PRELIMINARY OVERALL AREA DEVELOPMENT PLAN 432.8 Acres

Salado Trace POADP
P.O.A.D.P. NAME

Re: Salado Trace POADP
File #273

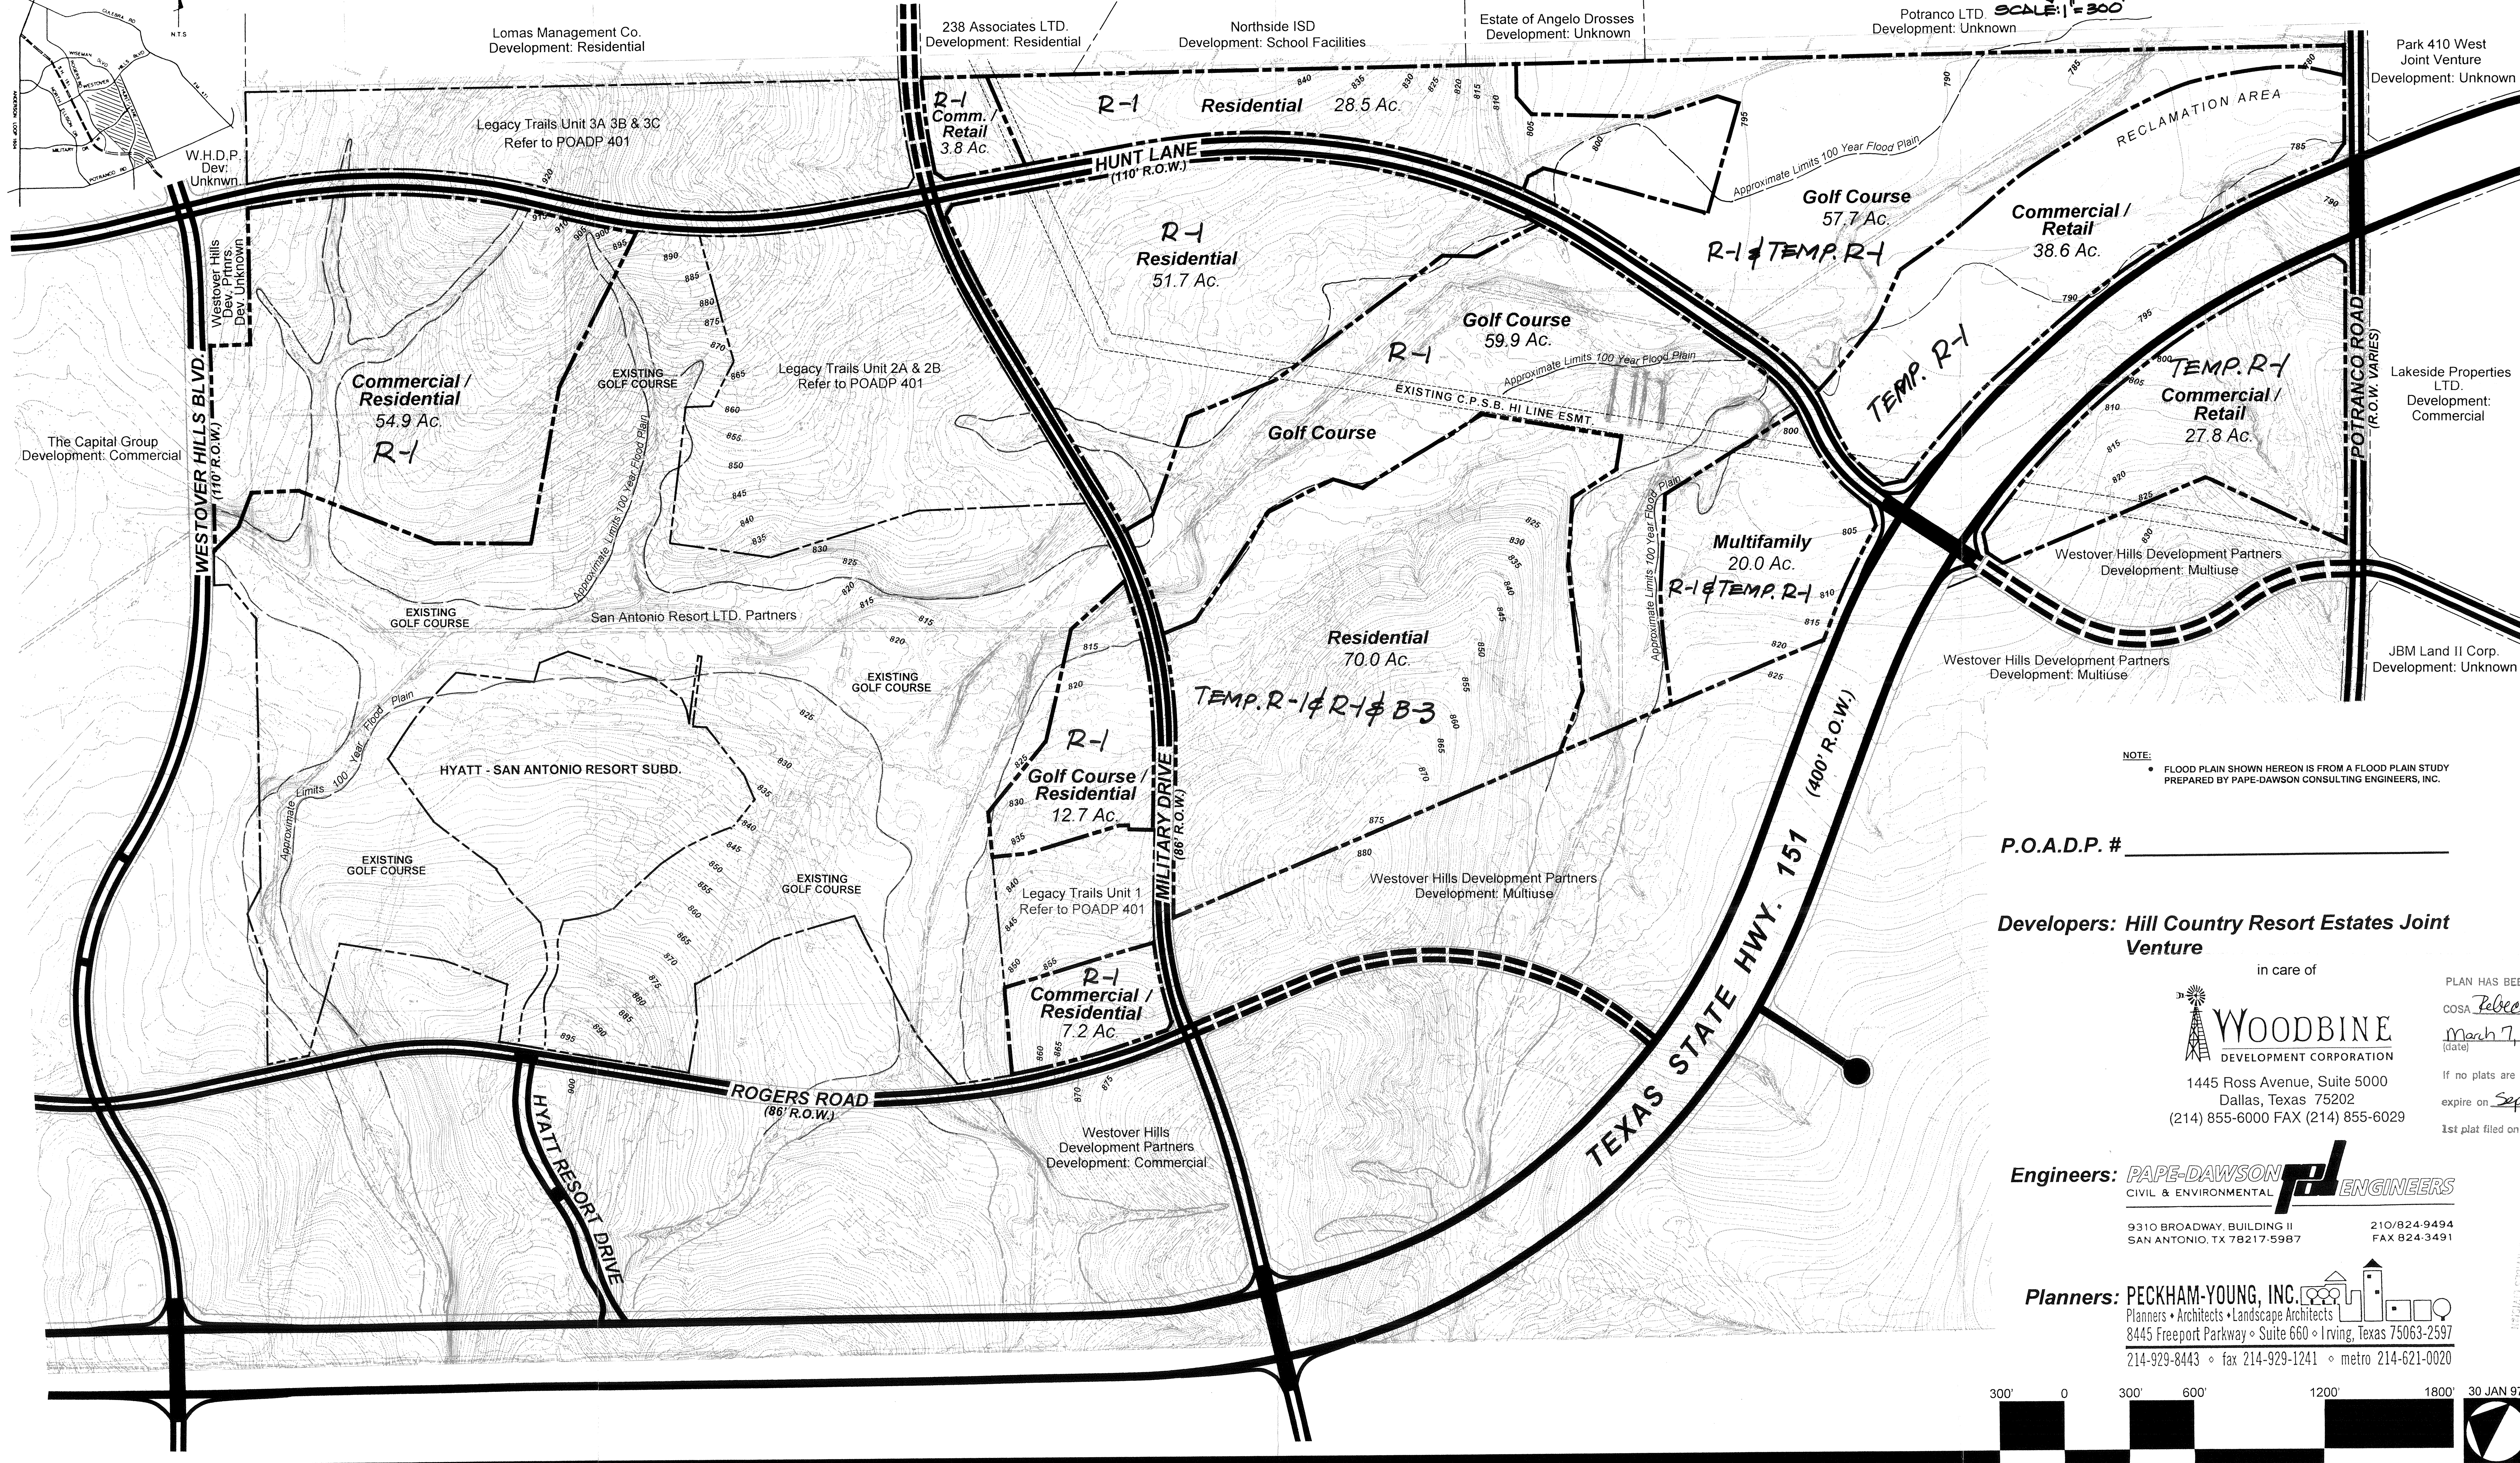
This is to inform you that the Staff Development Review Committee has reviewed and accepted your proposal plan for Salado Trace. This acceptance is subject to a cul-de-sac being provided on the proposed phase II on your plan. Because the proposed development is partly located adjacent to a landfill, a geological study or report will be required by the Environmental Protection Office at the time of platting. It is recommended that you contact Mr. Fred Meyers at 821-3557, prior to formalizing your plat submittal. Your POADP has been assigned Number 273 for future reference.
